Thank you for contacting the City of Sammamish regarding the current Shoreline Substantial Development Permit Application for East Lake Sammamish Trail Segment 2B (SSDP2016-00415).

**Re: Comments on SSDP2016-00415 Permit
From Chris & Tara Large
Trail Location: 311+00 / Property 4065100016 / Page 39 of 135 of Segment B 60% Plan**

From: Nick Tsilas [mailto:ntsilas@microsoft.com]
Sent: Friday, January 27, 2017 3:33 PM
To: Lindsey Ozbolt <LOzbolt@sammamish.us>
Cc: Jane Tsilas <janetsi@microsoft.com>; Nick Tsilas <ntsilas@microsoft.com>
Subject: Tsilas - Mint Grove residents – Comments and Questions on Section 2B East Lake Sammamish Trail Segment

DRAWING NUMBER: **A1.0**
 OF DRAWINGS

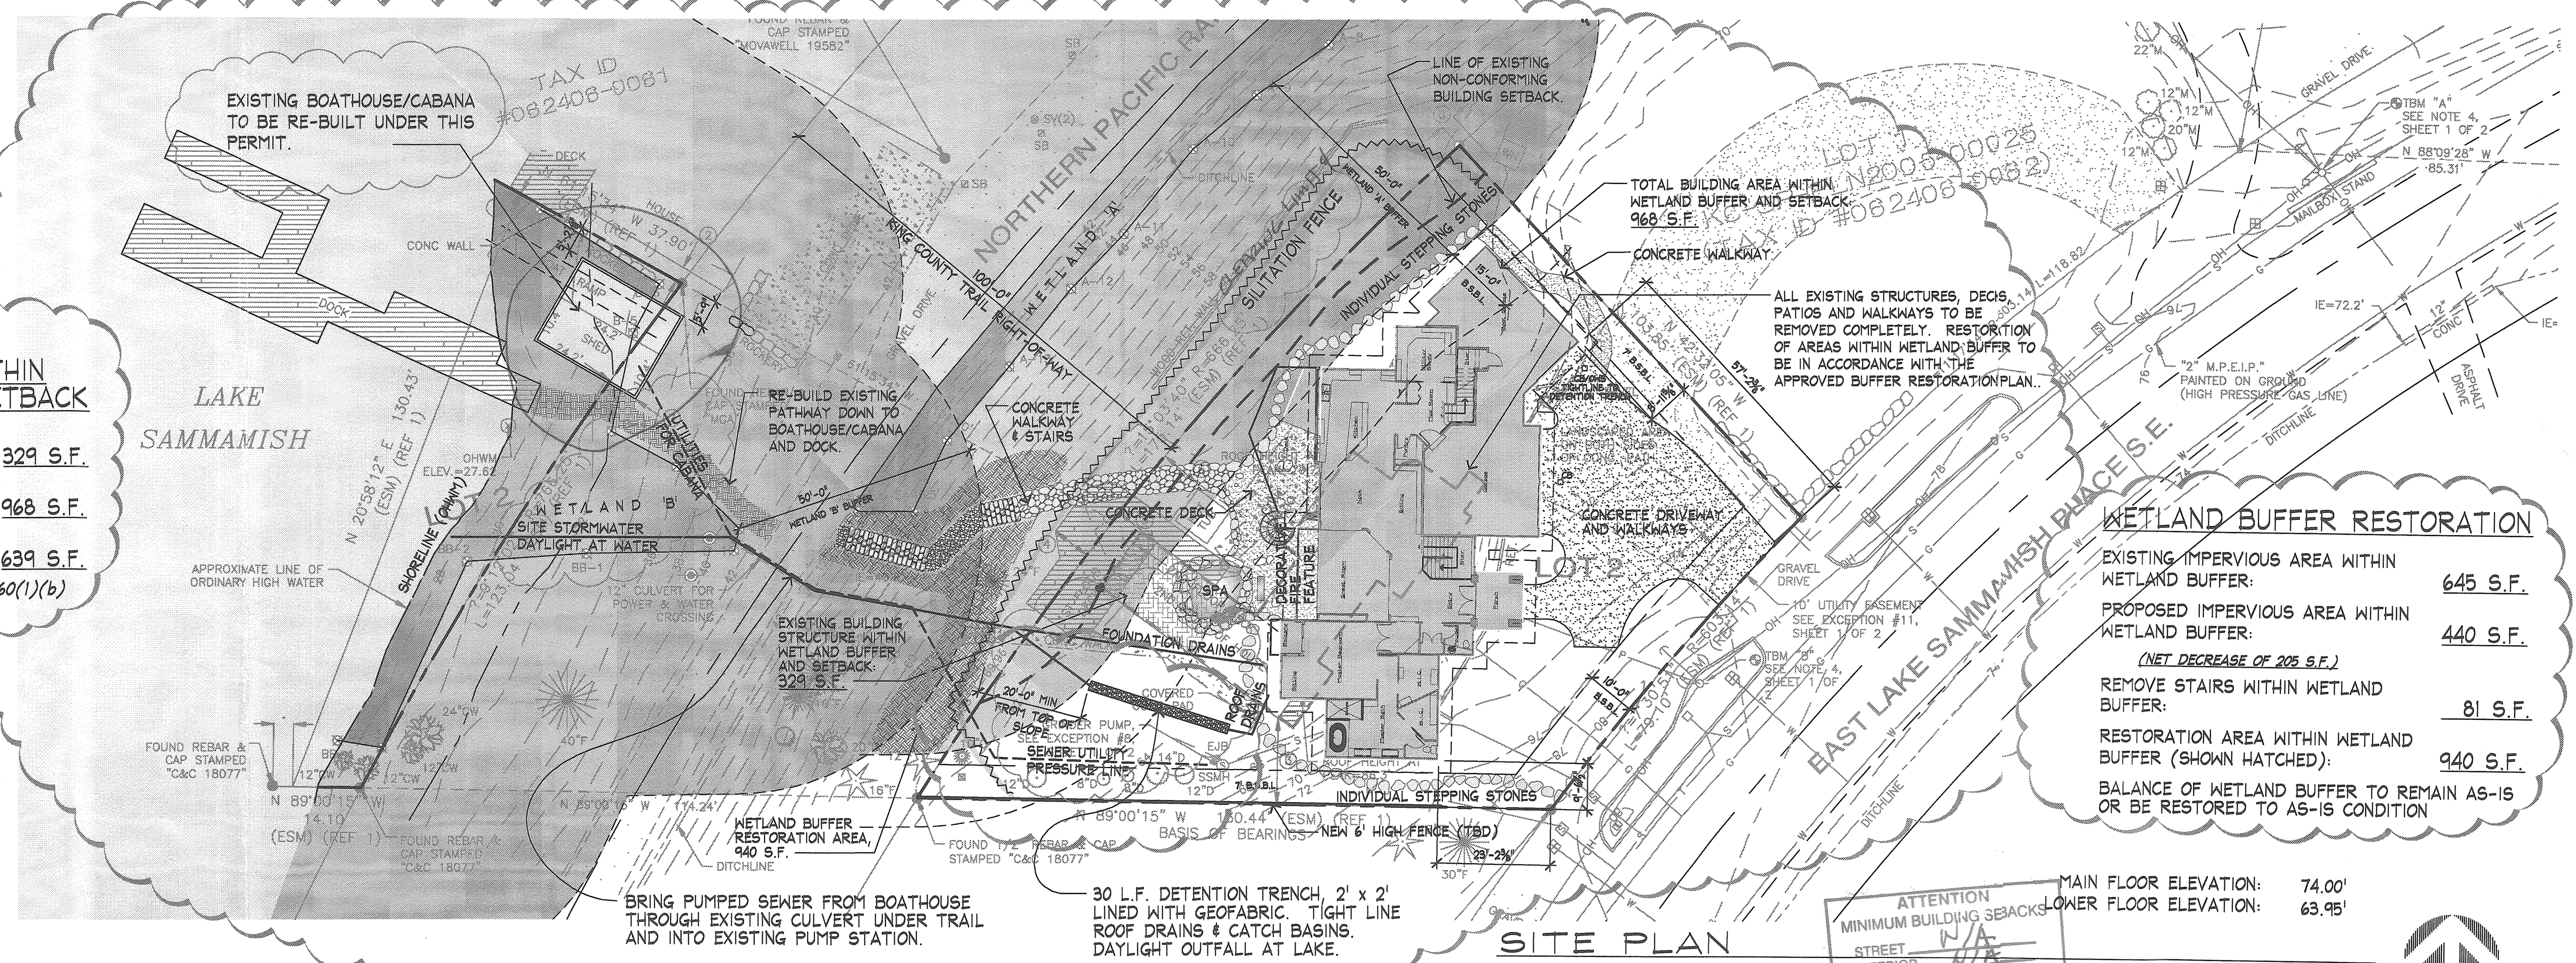
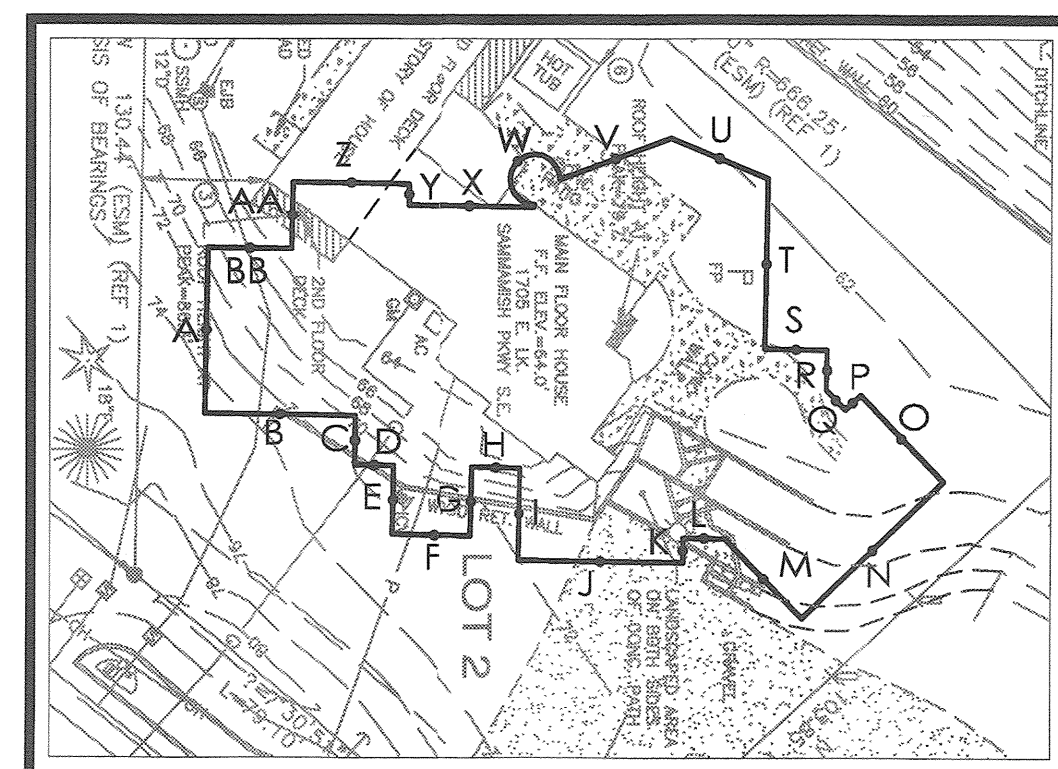
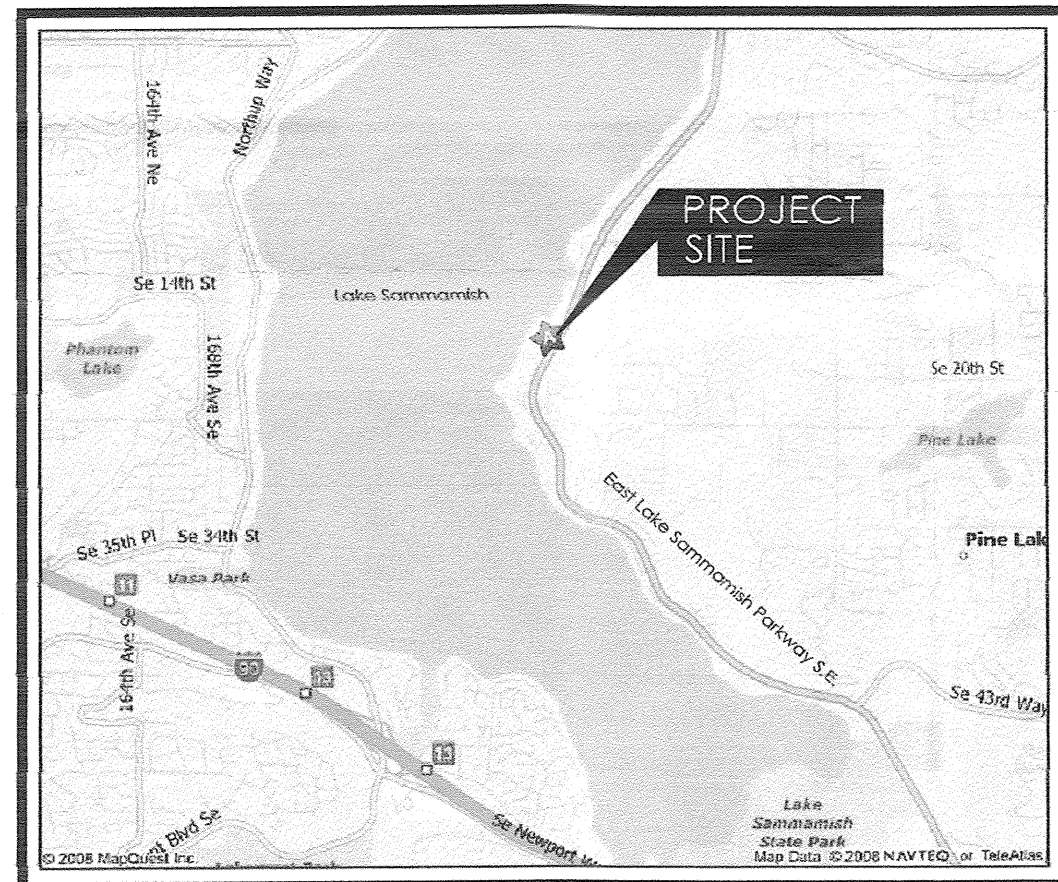
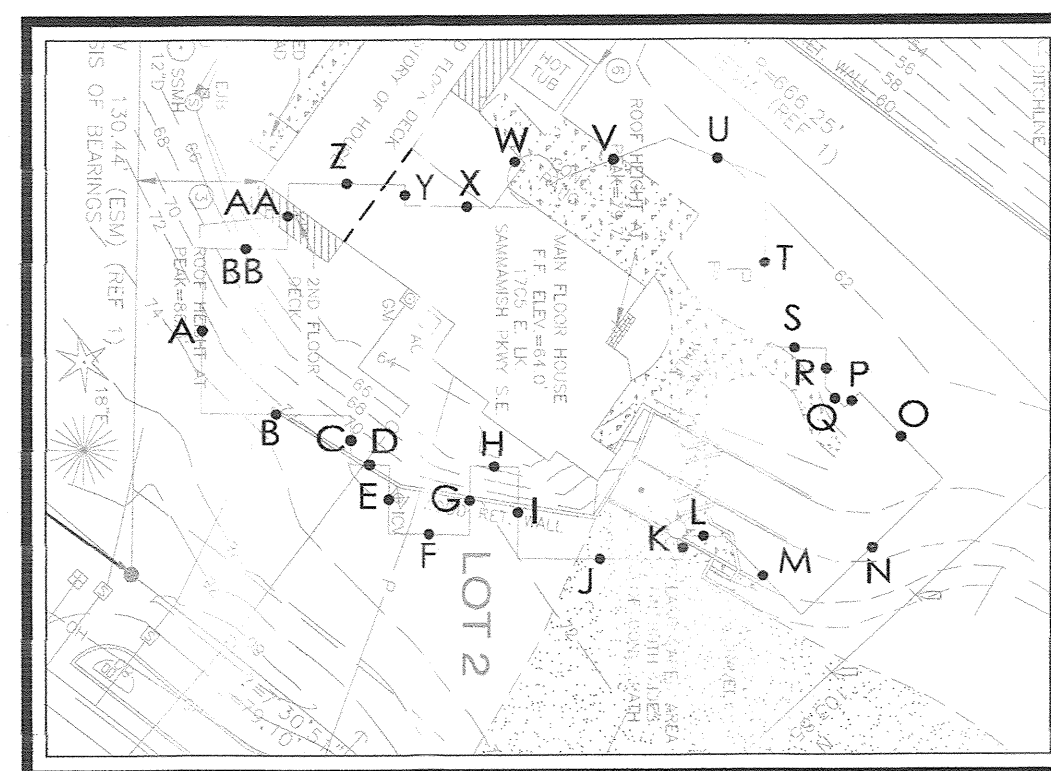
The 60% plans for show our stairs coming down from the house where the new construction is and going to be. Simply we want to make sure that when they do take a couple feet from that area that the landing is put back so we still have access to our lake house. The 60% plan shows the stairs but no real detail yet of the the landing as per the permit.

You'll see the walkway that was built from the trail to the lake house. This can be seen as part of the lake house permit as well. We would request that our access stays the same as with our permit. The 60% plan shows that our neighbor to the south and us will share a new access. I'm sure it's to save money however our permits show the access as it is now. We would respect that this does not change. The permit shows where we had to rebuild the existing pathway from the trail to the lake house.

I do not see where we are shown to have access to cross the construction to our lake house and and property. I would expect that since the stairs is our only access that a gate would be put in the fence for our access. Please note that for the build.

I do not see on the 60% plans where it show's my utilities crossing the trail. Please see on the lake house permit where the utilities cross the trail from the upper lot to the lake house. We are notify the city of these utility lines. Please be sure they do not cut these lines etc. Our lake house has full power and water and sewer with permits.

Snippet of Segment B 60% Plan covering our property; page 39

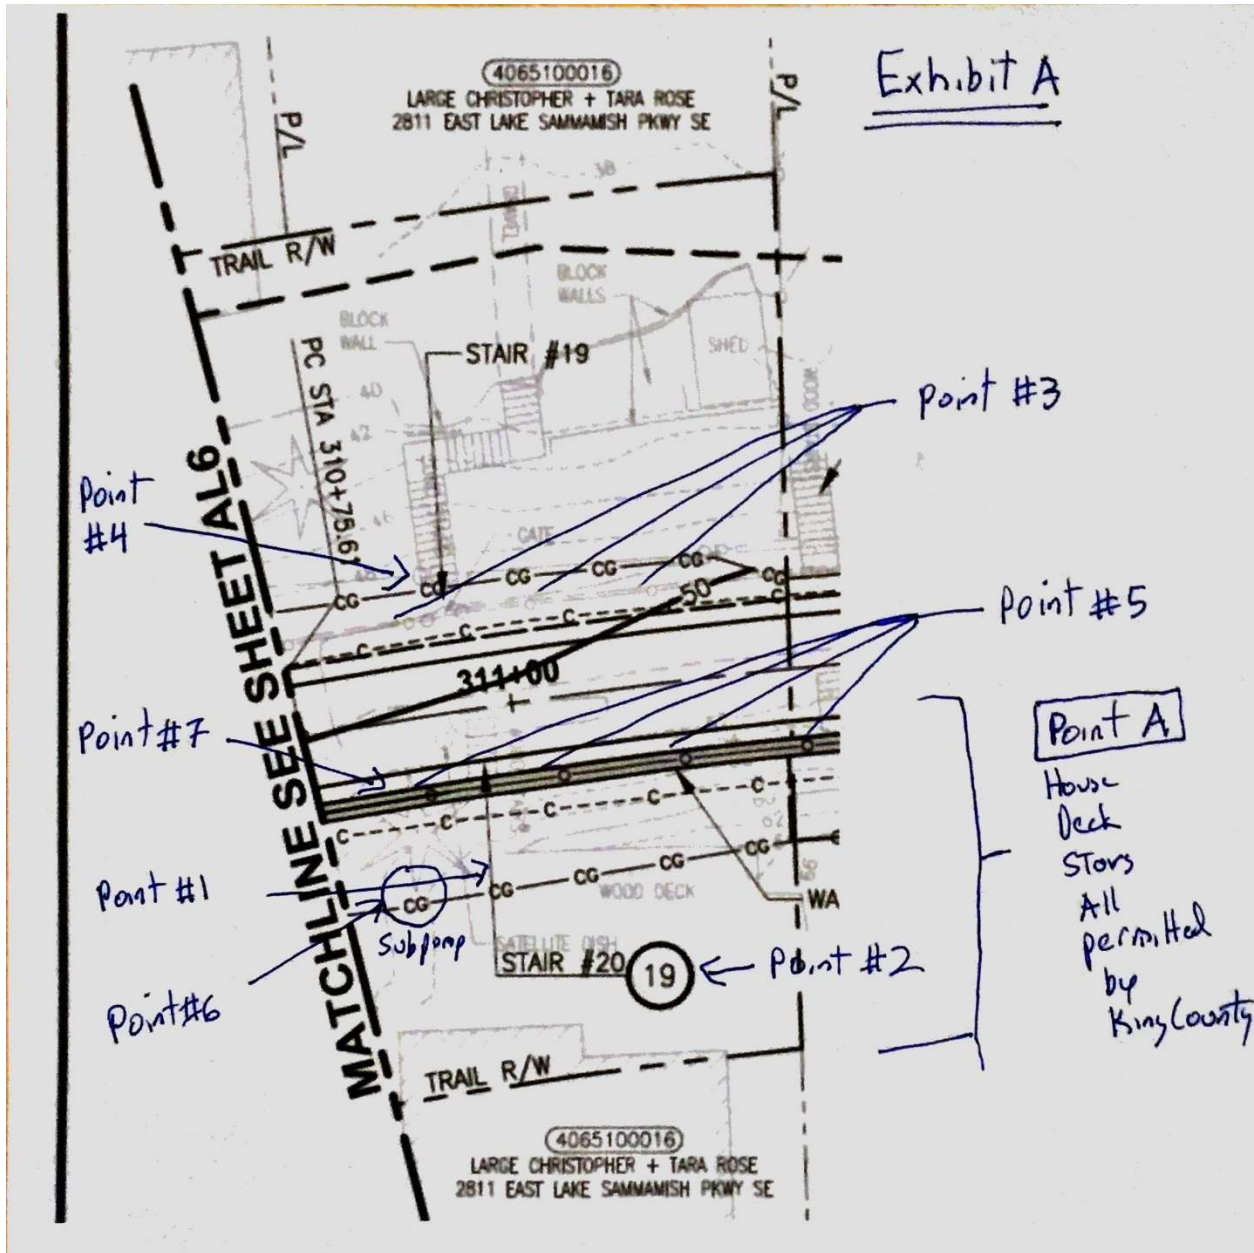
- 1) **Don't Impact Deck:** In the current plans, the Clearing and Grubbing line on the East side of the trail run through our deck, and based on our clarification meeting with King County (KC) – ***this means they will remove at least a good portion of the deck structure and deck.*** This deck structure and deck (& stairs) were permitted by King County back in 1970, and then the deck structure and deck (& stairs) improved upon and permitted in 1998-2000, so it is frustrating that they would remove a good portion of our deck (& stairs). Please see Permit #s 245526 & 247095, B98A1334, B99X3336, B00X1224.

- 2) **Provide Access to Trail and Replace “Stairs #20”:** In the current plans, the City states that Stairs #20 in bullet 19 - “STAIRS WILL BE ELIMINATED DURING CONSTRUCTION.” This staircase on the East side of the trail is the only access we have from our deck/house to get down to the trail to cross over to our property on the West side of the trail on the lake. Additionally, the plans include putting in Wall #6 running along the entire East side of the trail through our property so we don't have access to the trail and/or our property on the West side of the trail. Wall #6 is further outlined on Sheet 108 of 135 “S3” and is a soldier pile wall, ~ 5 feet high with a ~ 3.25 feet high coated chain link fence on top of the wall – along the trail in our section (311 +00). **Net: King County is removing stairs they permitted, and building a wall and fence eliminating our access from our deck/house to get to the trail, and to get to our property on the Lake on the West side of the trail.**

- 3) **Keep (or Replace) Privacy Fence and Gate on the West Side of Trail:** On the West side of the trail there is currently a very nice coated chain link fence with a privacy screen running the length of the trail through our property, and a very nice gate to prevent strangers from entering our property on the West side of the trail by the Lake. This fence and gate are between the clearing and the Clearing and Grubbing line in the 60% plan – so they will be removed during the construction of the trail, and there is nothing showing the fence and gate will be replaced. ***We are very concerned about the safety of our three children and their friends playing on our property by the Lake, and very concerned that someone may steal or vandalize our shed, contents stored in the shed, and our boat if people have unobstructed access with the removal of the fence and gate.***

- 4) **Ensure "Stair #19" is not Impacted:** It is not clear whether the Clearing and Grubbing line runs through "Stair # 19", so we are concerned that "Stair # 19" will be impacted when constructing the trail.

- 5) **Ensure Our Deck and House Foundation are not Impacted:** The plans include putting in Wall #6 running along the entire East side of the trail through our property. Wall #6 is further outlined on Sheet 108 of 135 "S3" and is a soldier pile wall, ~ 5 feet high with a ~ 3.25 feet high coated chain link fence on top of the wall – along the trail in our section (311 +00). Given our house and deck are built up on the hill above where the trail and this wall will go in, and especially considering that this new wall will cut into the steep hill significantly - we want to ensure the trail and wall will not impact our deck and home. For example, we are worried about anything that would cause the deck or house foundation to shift, which would cause a safety hazard, significant damage, and costly repairs. We are also concerned with puddling, soil stabilization and drainage techniques.

- 6) **Ensure Existing Utilities are not Impacted, and Provide Access for Future Utilities:** We are concerned that the plans do not show the different utilities (gas, water, sewer, electricity, etc.), so we are concerned these will be impacted by the construction and the trail. For example, there is a waste sub-pump serving multiple houses just to the South of our deck near the existing large tree that will be removed – that is not captured on the current plans. Additionally, we plan to build an accessory dwelling unit (i.e. dock house) in the future on the property to the West of the trail – so we would like to have utility conduits (e.g. tunnels or pipes) built under the trail so we don't have to disturb the trail in the future.

- 7) **Concrete Treatment on Wall #6:** We did not see in the plans any indication that King County will put a concrete treatment on the soldier pile wall.

- **Request:** Please ensure there is no impact to our existing deck and deck structure. This can be accomplished easily by moving the Clearing and Grubbing line to the West so that it does not intersect with or impact our deck structure or deck. King County should have enough room to still put in the trail and wall (@ the replacement stairs below) without impacting our deck.

- **Request:** Please ensure that our staircase #20 is replaced so that we have access to the trail, and our property on the West side of the trail on the Lake. The plans call for building replacement staircases for our neighbors to the north (Stair #22 & Stair #23 at 312 +00, and Stair #25 and Stair #26 at 313 +00) to get access through the Wall #6 – so is only fair they provide us with similar stairs and access.

- **Request:** Please move the Clearing and Grubbing line to the East of the current fence and gate to ensure there is no impact to the existing fence, privacy screen, and gate. The gate and fence border on a steep slope that has vegetation to keep it stable – so I can't imagine why King County would want or need to do anything in this section of property.

- **Request:** Please ensure that the plans clearly state that "Stair #19" will not be impacted by the trail construction. Additionally, please move the Clearing and Grubbing line at the Eastern side of the top of "Stair #19" a few feet to the East to ensure there is no mistake made.

- **Request:** Please ensure when putting in "Wall #6" that the construction crews are careful and no impact occurs to our deck and house. We also want to review a soils report and the geotechnical engineering plan to ensure King County is minimizing the risk of foundation movement and settling, and draining issues impacting our deck/house and the property surrounding the trail.

- **Request:** Ensure existing utilities are not impacted. Please build utility conduits under the trail so we don't have to disturb the trail when we build on the West side of the trail in the future.

- **Request:** Please ensure the County will put a concrete treatment on the soldier pile wall, similar to what they have done in other sections.
